SAFETY RECALL NOTICE

SIGNODE AND ACME TENSIONERS

August 1, 2011

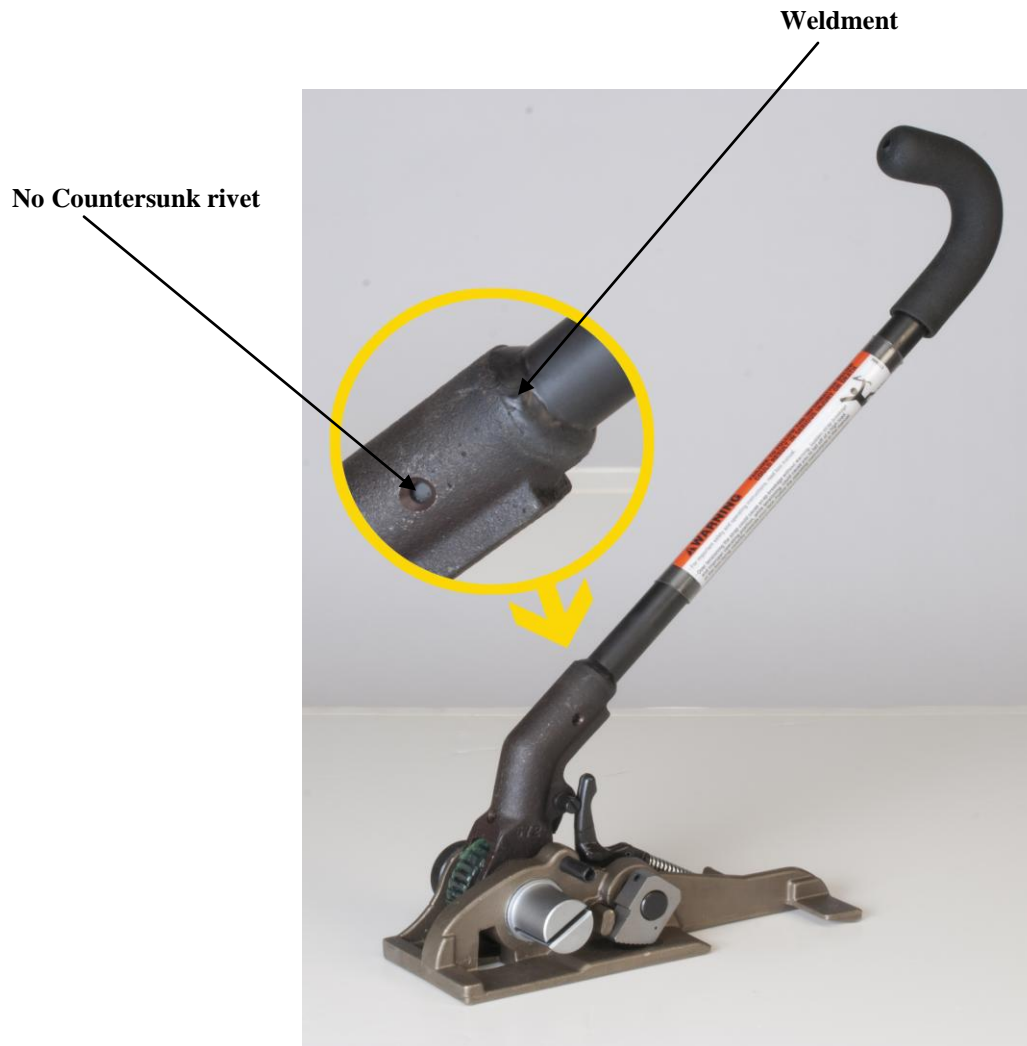
Around September 2009, Signode and Acme manufactured a **TENSIONER** with the tensioner's curved handle and yoke welded together. The "Yoke-Handle Assembly" of these tensioners was manufactured by welding the curved handle to the yoke **and was made without the use of a countersunk rivet**. We recently learned that these **TENSIONERS** may present a potential safety hazard. Customers **must** stop using these **TENSIONERS** immediately. Please be aware that only the **TENSIONERS** noted below are subject to this Safety Recall Notice.

The weldment that secures the **TENSIONER**'s yoke to the curved handle, as shown in the photo below, may rupture or break. If the weldment ruptures or breaks while the tool is being operated, the curved handle could release from the yoke. If this occurs, the operators could lose their balance, which could result in serious personal injury.

The old welded handles will be replaced with the “Yoke-Handle Assembly” that includes the countersunk rivet, at no charge.
